UNITED STATES PATENT AND TRADEMARK OFFICE

APPLICATION NO.	FILING DATE	FIRST NAMED INVENTOR	ATTORNEY DOCKET NO.	CONFIRMATION NO.
10/016,054	12/06/2001	David J. Nelson	83186WRZ	4831

Office Action Summary

FIG. 1

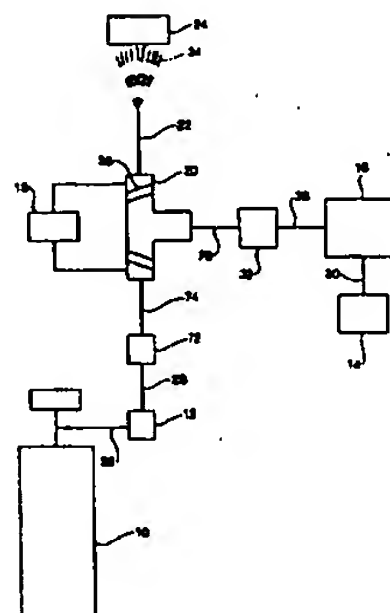
- {claim 1} A printhead for delivering a solvent free marking material to a receiver (fig 3, ref 52 ; column 4, lines 7-9); a discharge device having an inlet and an

outlet, a portion of the discharge device defining a delivery path, a portion of the discharge device being adapted to be releasably connected to a pressurized source of a thermodynamically stable mixture of a fluid and a marking material at the inlet, the discharge device being configured to produce a shaped beam of the marking material, the fluid being in a gaseous state at a location beyond the outlet of the discharge device (figure 1, reference 20, 22; column 11, lines 44-67; column 12, lines 15-36)

- {claim 12} a receiver retaining device positioned a predetermined distance from the outlet of the discharge device (figure 1, reference 24)
- {claim 26} a source of fluid connected to the pressurized source (figure 1, reference 10, 14)
- {claim 27} a source of marking material connected to the pressurized source (figure 1, reference 14)
- {claim 28} the pressurized source includes an inlet adapted to receive the marking material (figure 1, reference 30)
- {claim 46} a receiver positioned on a surface of the receiver retaining device (figure 1, reference 24)

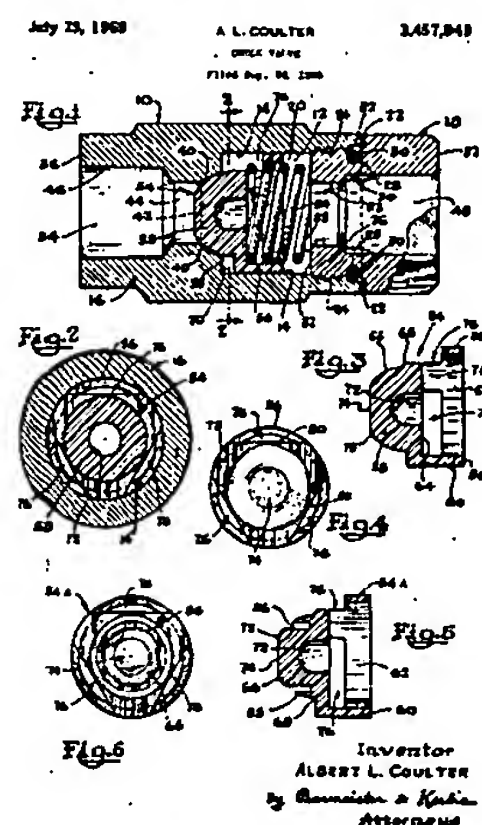
- {claim 1} an actuating mechanism positioned along the delivery path, the actuating mechanism having a first position removed from the delivery path and a second position in the delivery path (figure 1 reference 54)

- {claim 2} the discharge device includes a variable area section (figure 1, reference 40)
- {claim 3} the discharge device includes a constant area section (figure 1, drawn in)

- {claim 4} the discharge device includes a first variable area section connected to one end of a first constant area section, and a second variable area section connected to another end of the first constant area section (figure 1, reference 40; column 1-6)

- {claim 6} the actuating mechanism includes a position controllable actuating mechanism (figure 1; column 1, lines 12-44)
- {claim 11} an actuating mechanism positioned along the delivery path, the actuating mechanism having an open position at least partially removed from the delivery path (figure 1; column 1, lines 12-44)

- {claim 29} the discharge device has a variable area section (figure 1, reference 40)
- {claim 30} the discharge device includes a constant area section (figure 1; drawn in)

- {claim 31} the discharge device includes a first variable area section connected to one end of a first constant area section, and a second variable area section connected to another end of the first constant area section (figure 1, reference 40; column 1-6)

- {claim 32} a second constant area section connected to the second variable area section (figure 1; drawn in)
- {claim 33} the second constant area section having a first predetermined diameter, the second variable area section having a second predetermined diameter, wherein the first predetermined diameter is substantially equal to the second predetermined diameter (figure 1, reference 40; drawn in second constant area)

- {claim 34} the second predetermined diameter is a maximum diameter of the second variable area section (figure 1, reference 40)
- {claim 35} the first constant area section having a third predetermined diameter, the first variable area section having a fourth predetermined diameter, wherein the third predetermined diameter is substantially equal to the fourth predetermined diameter (figure 1, reference 40; drawn in first constant area)

- {claim 36} the fourth predetermined diameter is a minimum diameter of the first variable area section (figure 1, reference 40; segment both minimum and maximum diameter)

- {claim 44} the actuating mechanism includes a conical sealing element moveable between the open position and a closed position (figure 1, reference 54)
- {claim 45} the actuating mechanism includes a discloses shaped sealing element moveable between the open position and a closed position (figure 2)
